Agenda Item Transmittal

Agenda Title: Discuss and consider action on Site and NPS plans for the Pearl Multifamily development located at 13400 Bee Cave Parkway, Bee Cave, TX including the following plans:

**The Pearl
Bee Cave, Texas**

Re: Morgan (Applicant) Responses to P&Z Question

LEASING BUILDING - GLASS COVERAGE

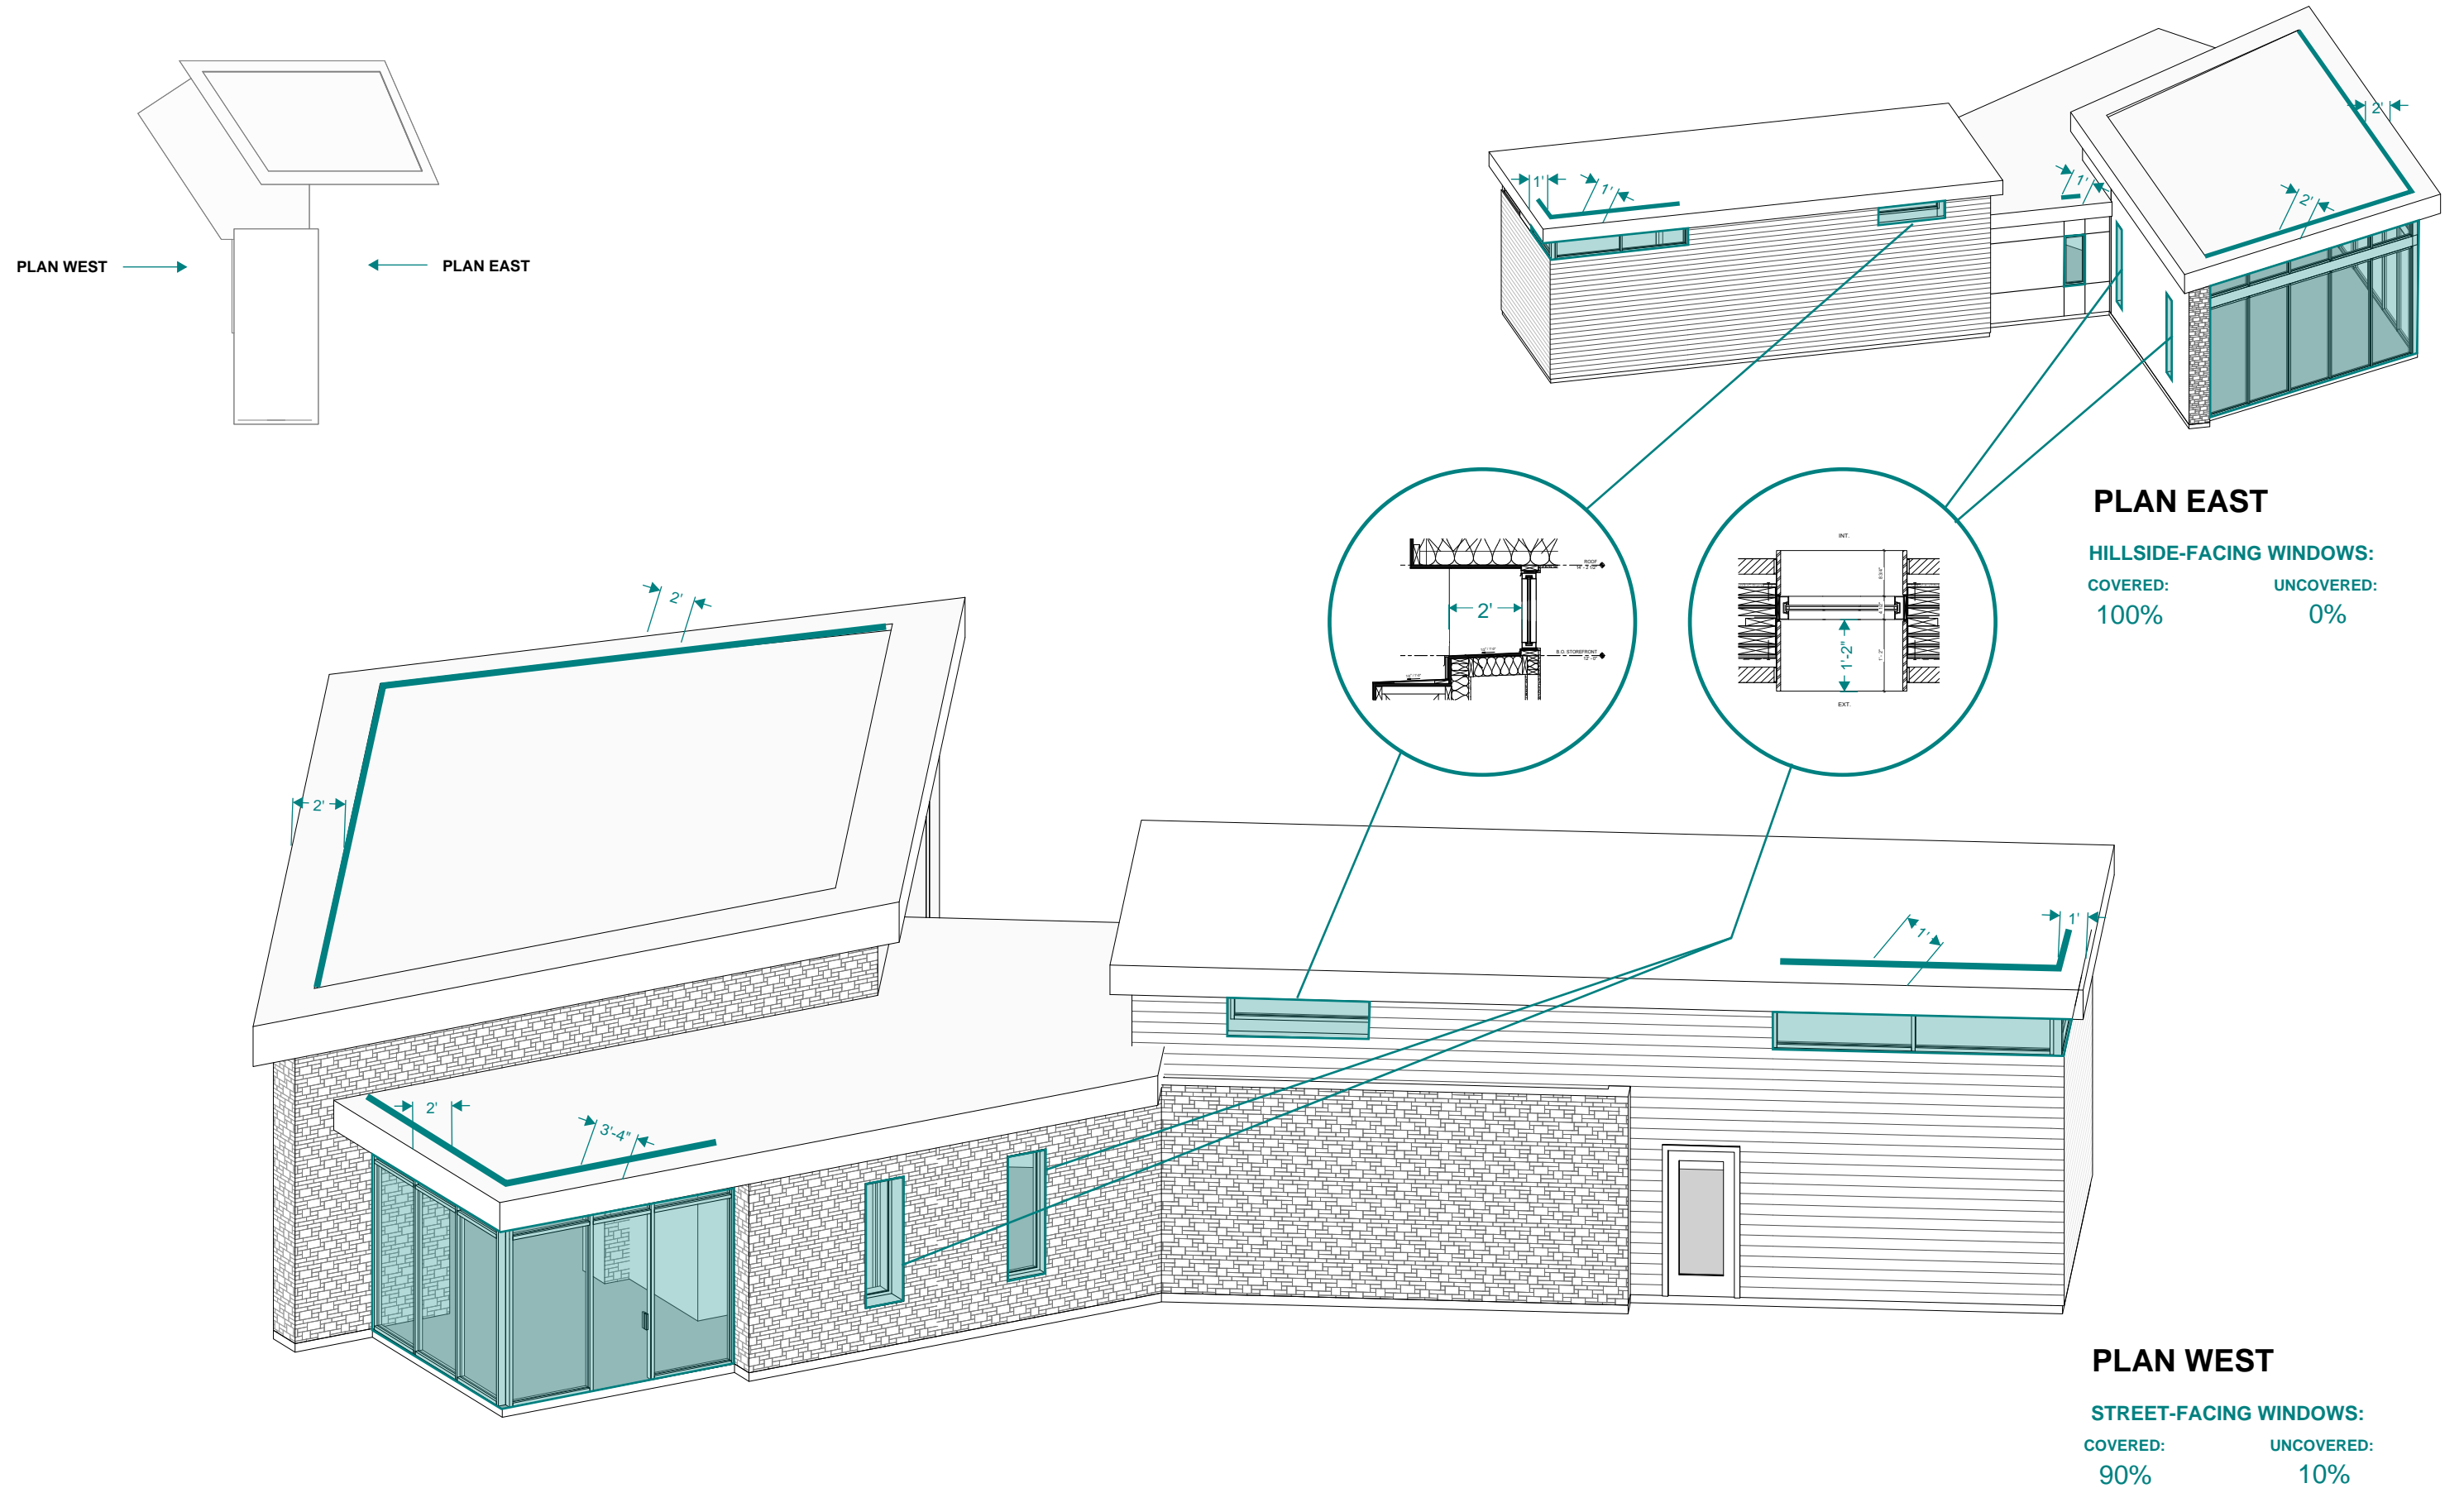
5. Leasing Building - Design Intent Compliance. Please see attached consultant report for explanation.

City Staff and Morgan reviewed the Leasing Office building in great detail to ensure full compliance with the design requirements of the PDD. With three different roof lines and multiple facades and angles along the building, City Staff determined that the building design complied with the the PDD.

The below exhibits detail the various elevations, roof lines, and material percentages of the leasing building facades.
